**DEVELOPMENT REVIEW BOARD MEETING
FEBRUARY 14, 2022
6:30 PM**

**DEVELOPMENT REVIEW BOARD
RESOLUTION NO. 399**

Exhibit A1
Staff Report
Frog Pond Crossing 29-Lot Subdivision
Development Review Board Panel 'A'
Quasi-Judicial Public Hearing

Application Nos.: DB21-0036 Annexation
DB21-0037 Zone Map Amendment
DB21-0038 Stage I Preliminary Plan
DB21-0039 Stage II Final Plan
DB21-0040 Site Design Review of Parks and Open Space
DB21-0041 Tentative Subdivision Plat
DB21-0042 Type C Tree Removal Plan
DB21-0043 Waiver - Open Space Location
DB21-0044 Waiver - Minimum Street Frontage

Figure 1. Alternative Street Layout from Preapplication Meeting

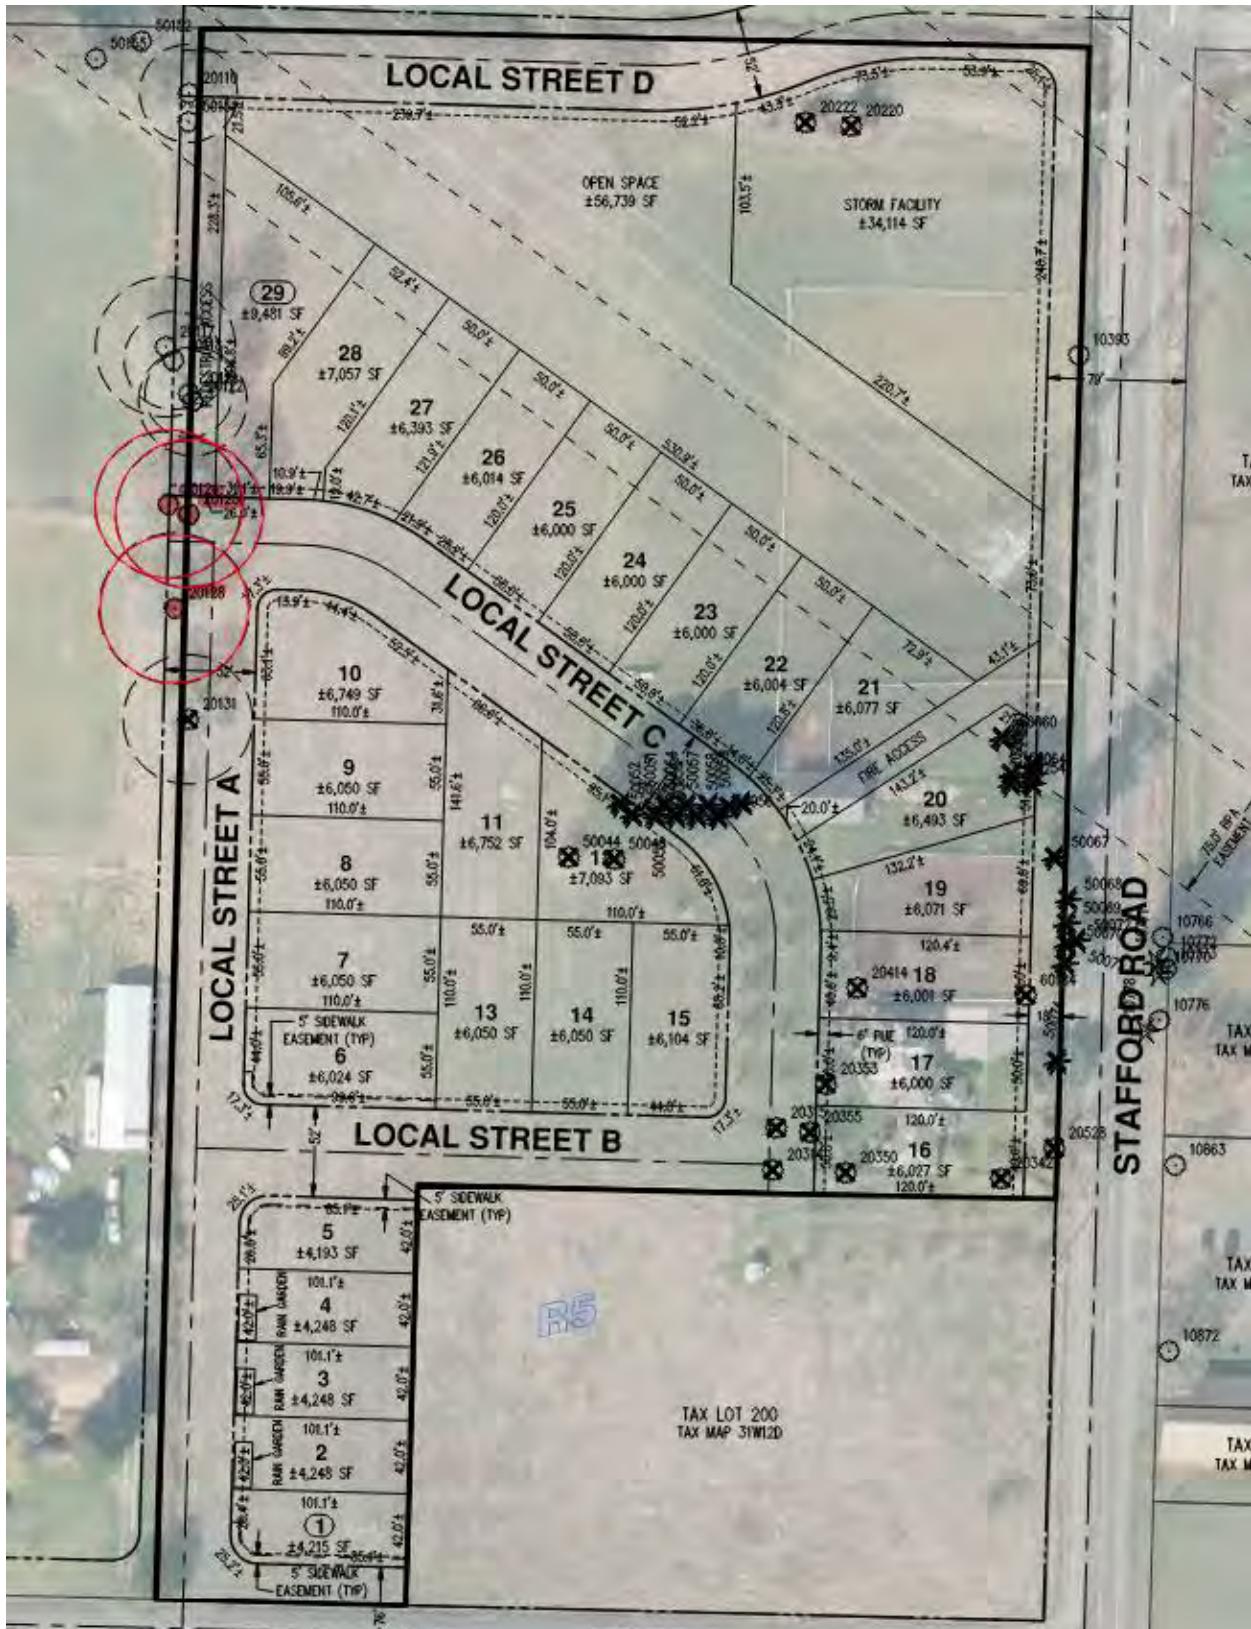
4. *Insufficient findings to explain deviations from the Street Demonstration Plan, particularly relating to the following (see Figure 18 of the Frog Pond West Master Plan and Subsection 4.127 (.10) WC.):*
 - *A missing Pedestrian Connection from Local Street A to Stafford Road in the eastern portion of the site.*

- *Substitution of a Pedestrian Connection for a Public Street in Tract C. While it is noted that this provides an equivalent level of pedestrian connectivity, the provided finding incorrectly identifies the location of the oak tree grove relative to this connection and the provided path and tract do not meet the cross section requirements, including minimum path and planter strip width, identified for Pedestrian Connections as illustrated in Figure 25 of the Frog Pond West Master Plan.*

Response: The narrative has been updated to identify the location of the oak tree grove relative to the pedestrian connection. The Applicant initially studied the site layout with a public street connection as envisioned by the Street Demonstrated Plan. That layout was submitted to City staff for review prior to the preapplication conference. As shown on Figure 1 below, the site design with the public street would require removal of three mature oak trees, which the proposed layout manages to preserve (20128 – 55” DBH, 20125 – 34” DBH, and 20124 – 36” DBH). Because Trillium Street is moved further to the south to avoid impacting the oak trees, the middle block area becomes smaller and lots 6, 7, 15 and 16 are affected. Although not directly in the path of the trees that are being preserved, reducing lot sizes in the middle block enables tree preservation immediately to the north.

In order to achieve the target residential density of 29 lots and provide needed housing while avoiding environmental impact to the onsite wetland and preserving the mature oak trees, the 26-foot width of the pedestrian right-of-way is required to be reduced. The proposed pedestrian connections in Frog Pond Crossing provide a minimum eight-foot paved path. The width of pedestrian right-of-way (ROW) in Tract A is ± 21 feet. The paved path is aligned along the eastern edge of the ROW to minimize any impact to the oak tree root system. Based on staff comments, pedestrian connection width in Tract C has been increased to ± 16.25 feet, which represents two thirds of the typical section. The remaining width can be accommodated in the adjacent Tax Lot 401, as tree preservation achieved through this layout benefits both properties.

Figure 2. Street Demonstration Plan

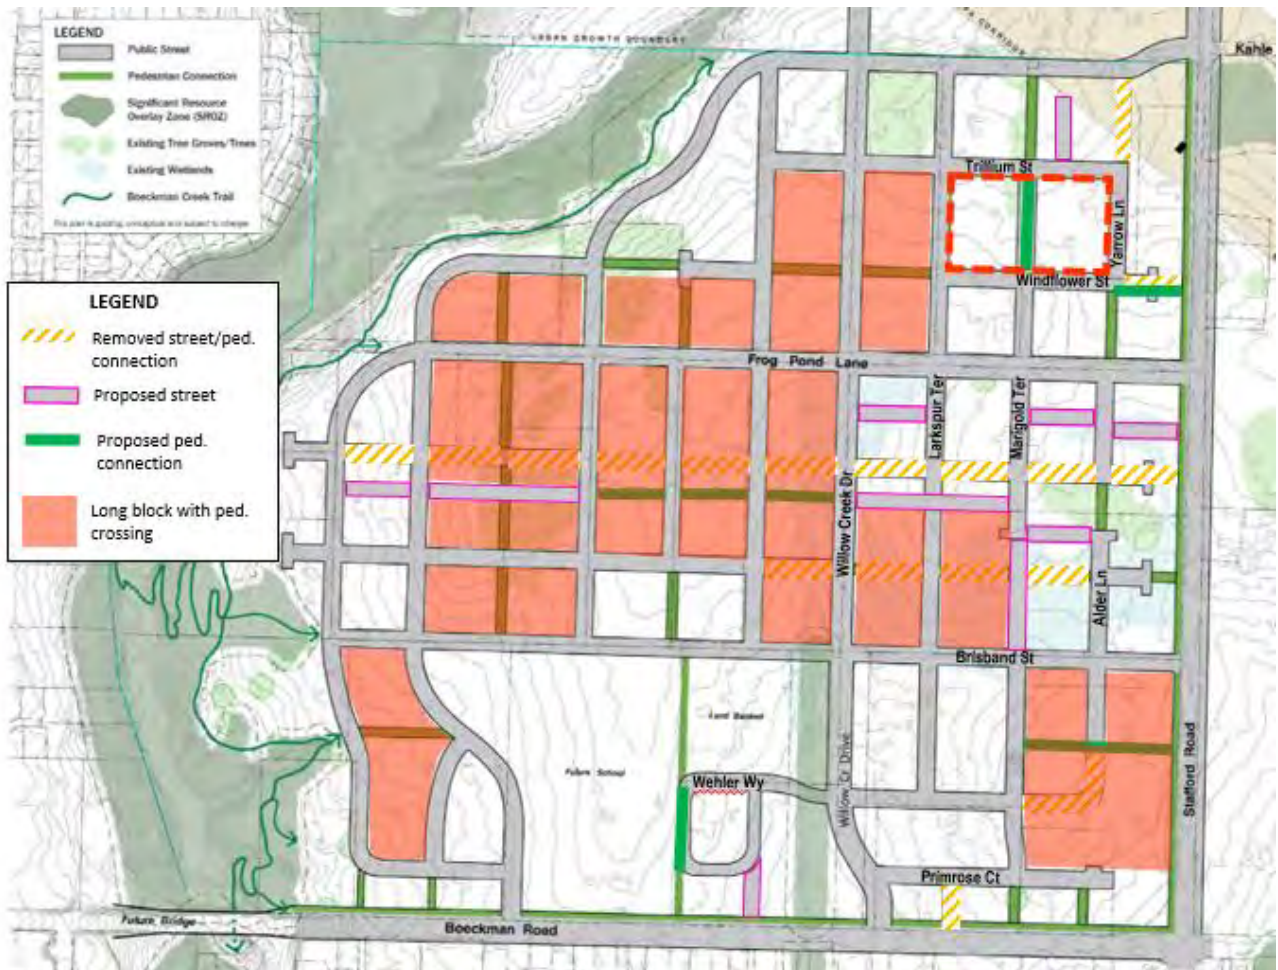
4. Insufficient findings to explain deviations from the Street Demonstration Plan, particularly relating to the following (see Figure 18 of the Frog Pond West Master Plan and Subsection 4.127 (.10) WC.):

- A missing Pedestrian Connection from Local Street A to Stafford Road in the eastern portion of the site.
 - Substitution of a Pedestrian Connection for a Public Street in Tract C. While it is noted that this provides an equivalent level of pedestrian connectivity, the provided finding incorrectly identifies the location of the oak tree grove relative to this connection and the provided path and tract do not meet the cross section requirements, including minimum path and planter strip width, identified for Pedestrian Connections as illustrated in Figure 25 of the Frog Pond West Master Plan.

The Applicant has been coordinating site planning with the owner of the adjacent property, therefore the proposed deviations from the Street Demonstration Plan in Frog Pond Crossing will not encumber the adjacent property. Furthermore, the proposed pedestrian connection mid-block does not create an unusual condition. As highlighted on Figure 2 below, Frog Pond West street network is not a fully conventional grid pattern. There are at least twelve long blocks with mid-block pedestrian connection that were either originally envisioned on Figure 18 in Frog Pond West Master Plan, or subsequently approved by the City through a modification. In Frog Pond Crossing, the proposed substitution of a street with a pedestrian connection in Tract C is justified by the preservation of three mature Oregon White Oak trees.
